<b>Product/Process Change Notice (PCN)</b>	
<input type="checkbox"/> Major Change <input checked="" type="checkbox"/> Minor Change	
<b>PCN Number:</b> PCN_IndMAIA_20250808  <b>Affected Series:</b> WE-MAIA  <b>Affected Part Number:</b> 78438324015HT, 78438335033HT, 78438336022HT  <b>PCN Date:</b> 2025-02-07 (YYYY-MM-DD) <b>Effective Date:</b> 2025-08-08 (YYYY-MM-DD)	<b>Change Category:</b> <input type="checkbox"/> Equipment/Location <input checked="" type="checkbox"/> General Data <input type="checkbox"/> Material <input type="checkbox"/> Process <input type="checkbox"/> Product Design <input type="checkbox"/> Shipping/Packaging <input type="checkbox"/> Supplier <input type="checkbox"/> Software
<b>Contact:</b> Product Management  <b>Phone:</b> +49 (0) 7942 - 945 5001  <b>Fax:</b> +49 (0) 7942 - 945 5179  <b>E-Mail:</b> pcn.eisos@we-online.com	<b>Datasheet Change:</b> <input checked="" type="checkbox"/> Yes <input type="checkbox"/> No  <b>Attachment:</b> <input type="checkbox"/> Yes <input checked="" type="checkbox"/> No

<b>DESCRIPTION OF CHANGE:</b> <p>Because of a database mismatch, Würth Elektronik eiSos will correct the "Performance Rated Current" value of the mentioned part nu

Affected part number: 78438324015HT

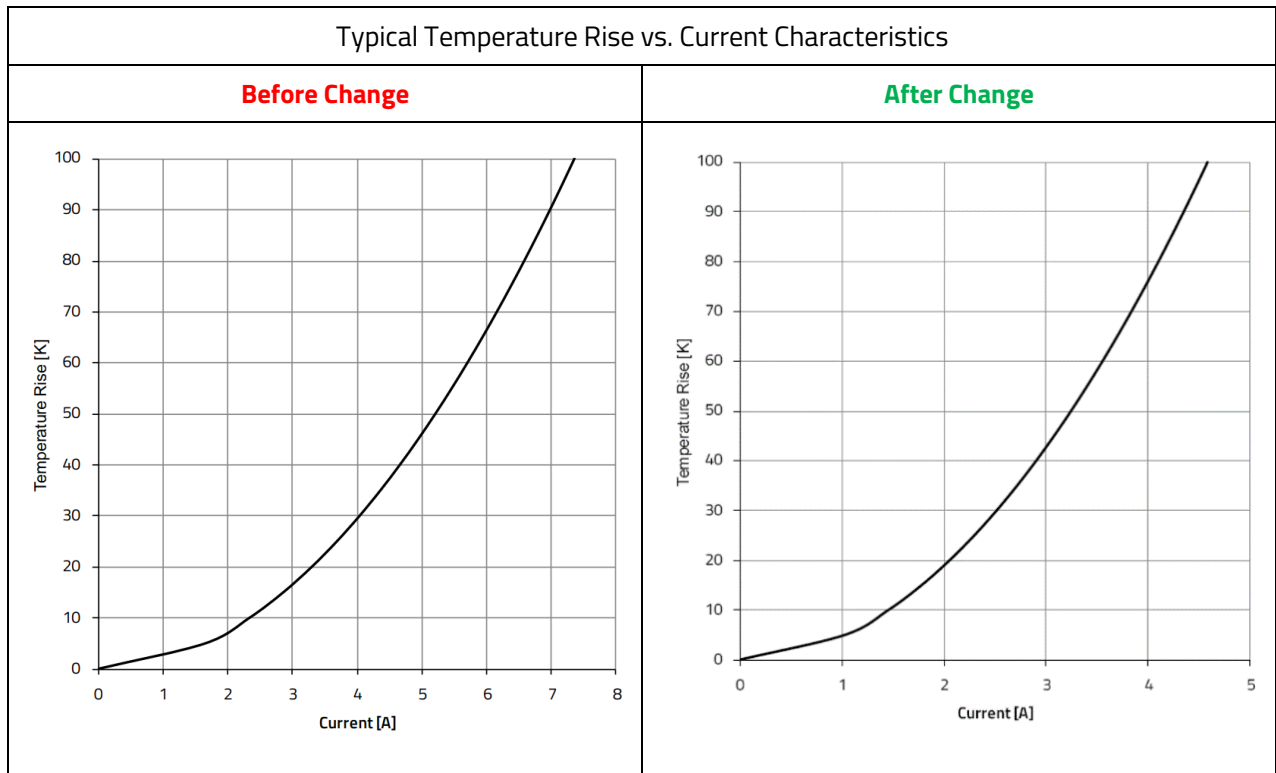
Performance Rated Current ( $I_{RP,40} / \Delta T = 40 \text{ K}$ )	
Before Change	After Change
4.7 A (max.)	2.9 A (max.)

Affected part number: 78438335033HT

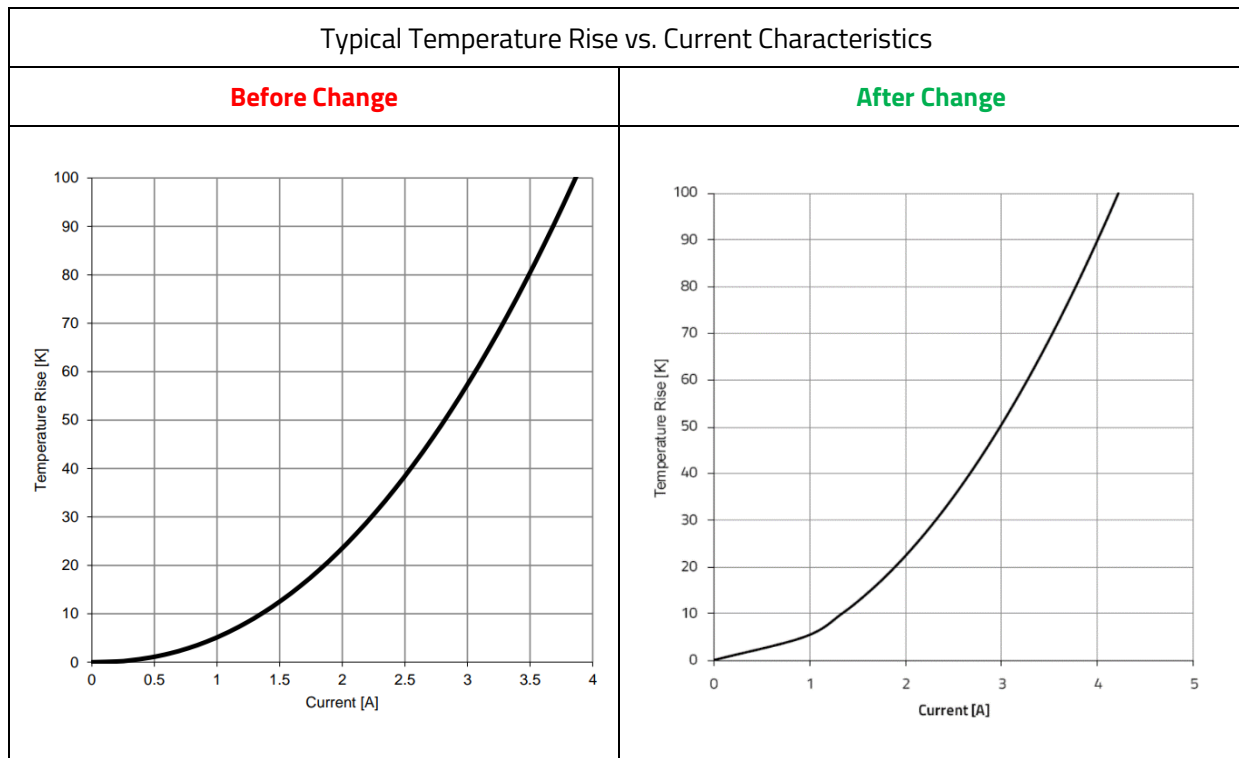
Performance Rated Current ( $I_{RP,40} / \Delta T = 40 \text{ K}$ )	
Before Change	After Change
2.6 A (max.)	2.7 A (max.)

Affected part number: 78438336022HT

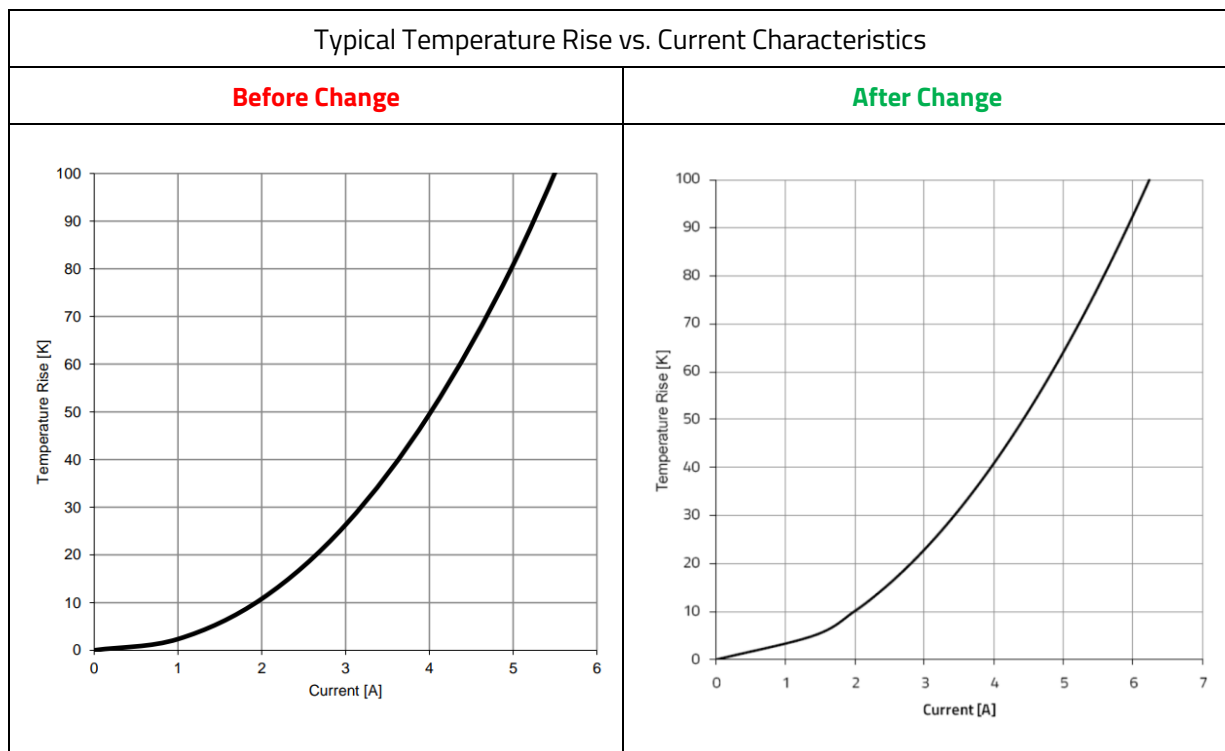
Performance Rated Current ( $I_{RP,40} / \Delta T = 40 \text{ K}$ )	
Before Change	After Change
3.6 A (max.)	4 A (max.)
